RECEIPT DATE: 3/23/17 **ONSITE SEWAGE DISPOSAL SYSTEM** P 560580

PROPERTY ADDRESS: 2038 Drovers Lane

SUBDIVISION: Vista Ridge LOT: 11 TAX ID: 04-595476

TITLE: SEPTIC PLAN

PRE-CONSTRUCTION:

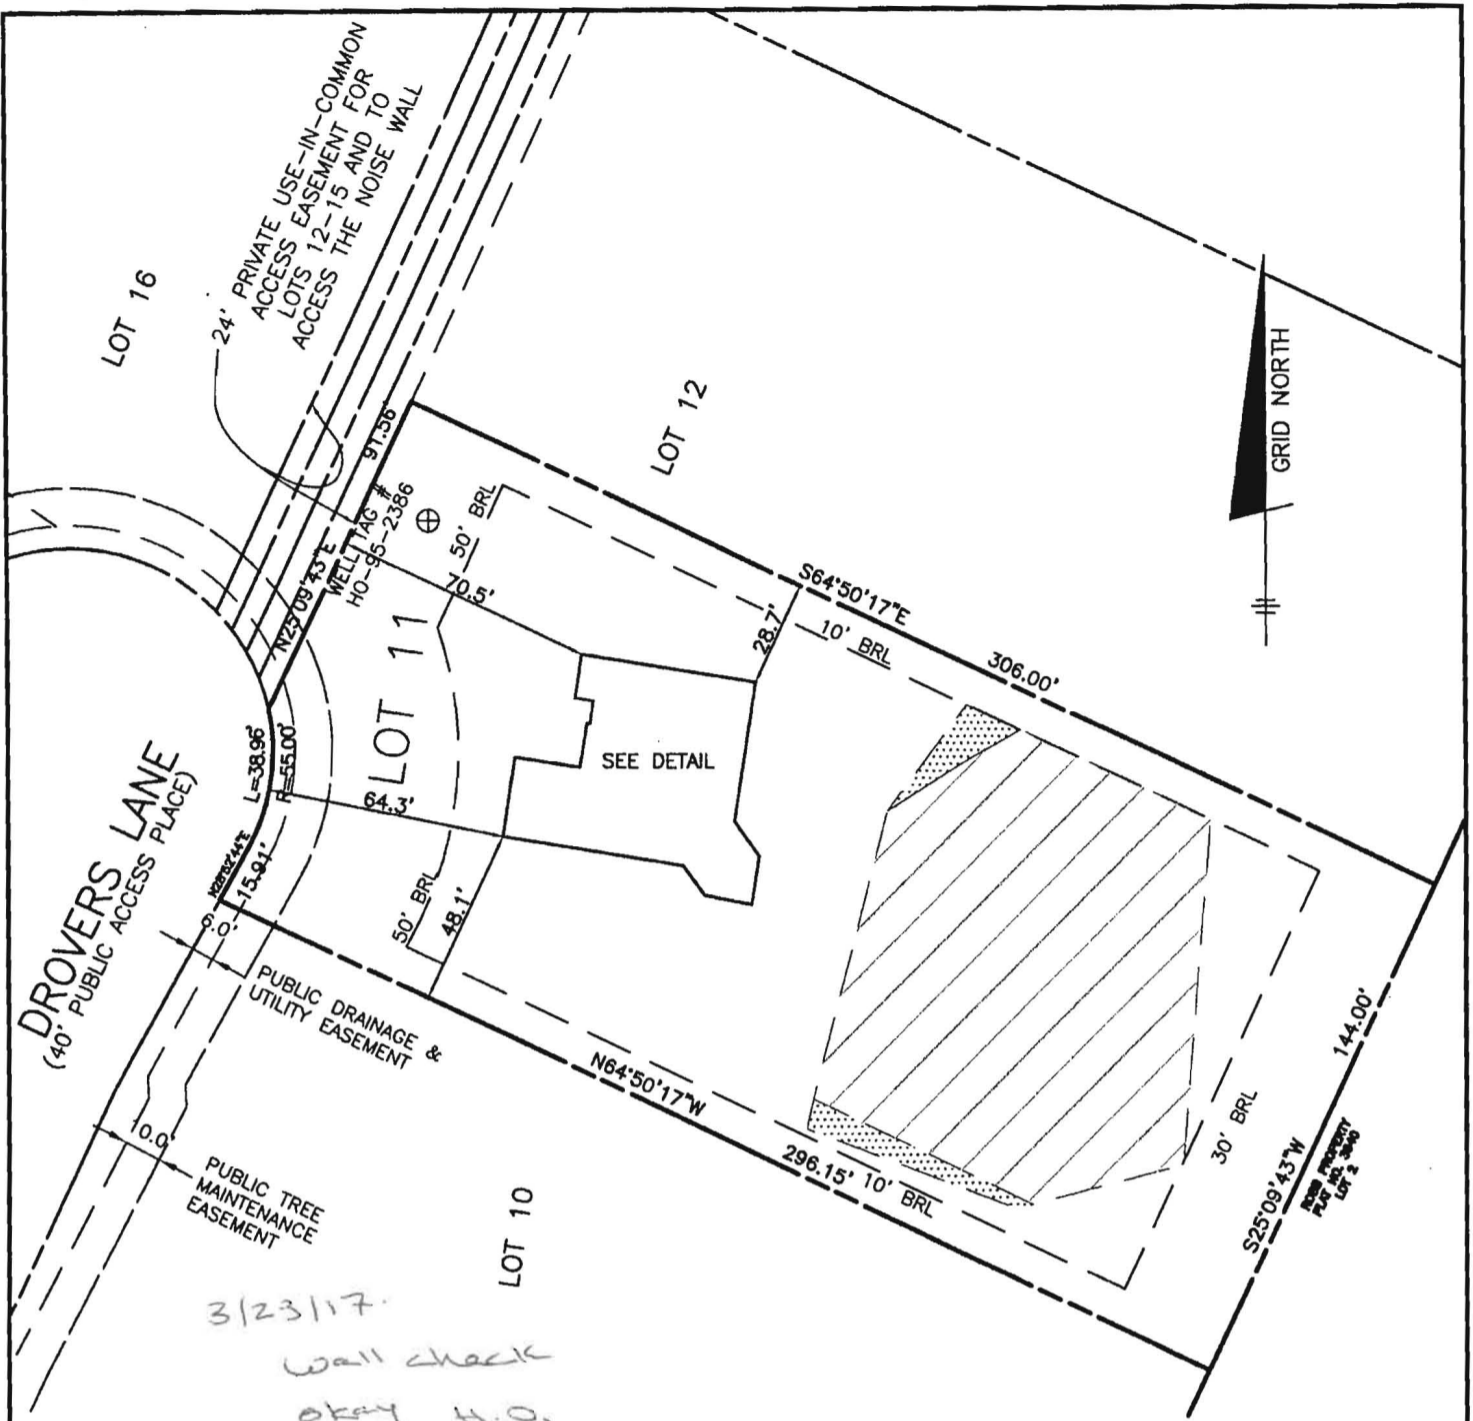
7/13/17 Met Fogle's + superintendant Jason on site for layout. SDA corners staked, tank not staked. Set tank location per plan - will need a traffic-bearing tank. Trees must be cleared in upper part of SDA prior to doing trench layout. OK to set tank. (SC)

7/18/17 Shot contour + laid out 4x59' trenches. Contour not as shown - trenches have less curvature. Dug a test hole in SDA above T1, little rock (see perc notes). Must use laser while digging trenches. (SC)

INSTALLATION: 7/17/17 Fogle's digging tank hole, hitting rock from surface to bottom. House connection made. (SC) 7/17/17 On site for setting tank - took some adjustments to get it level. NO obvious cracks on bottom or sides. (SC) 7/18/17 T1 dug, Fogle's adding stone, 3' wide, 5' inlet, 8' bottom. Little rock in spoil piles. (SC) 7/19/17 T2 + T3 complete + left open @ ends for inspections - 3' wide, 4-4.5' to stone. Fogle's digging T4 + using laser, 8' bottom. (SC)

7/20/17 T4 complete + left open for inspection. 3' wide, 4' to stone. Levelled speed levelers in D-box - outlet pipe to T4 is leaking. Other pipes backfilled @ box, couldn't tell if they leaked. Seal all with hydraulic cement, plus crack near T4 pipe, upper part. (SC) 7/21/17 D-box pipes sealed w/ hydraulic cement, crack sealed. Levelled speed levelers in D-box. (SC)

PLAN VIEW
1" = 30'

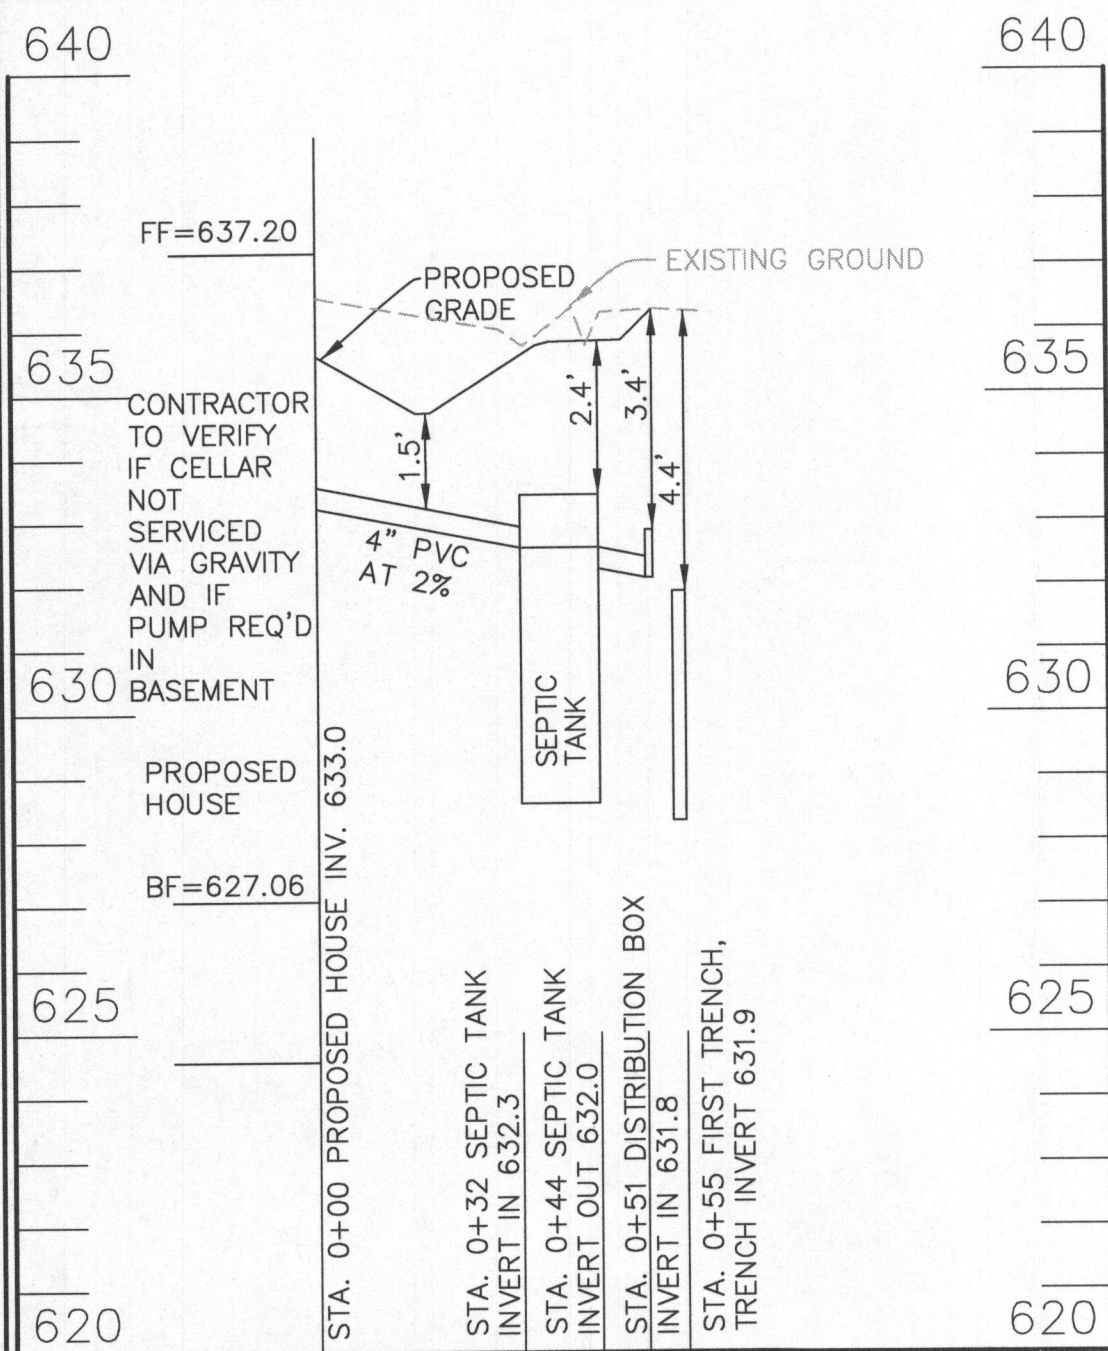
On the OSDS plans for Vista Ridge Lots 11, 13 & 17 (2038, 2046, 2037 Drovers Lane) I would like to red line the note: "The maximum earth cover over the tank is 3 feet. Greater earth cover will require a heavy load bearing tank". Would you be ok with this?

- The maximum earth cover over the tank is 3 feet. Greater earth cover will require a heavy load bearing tank.
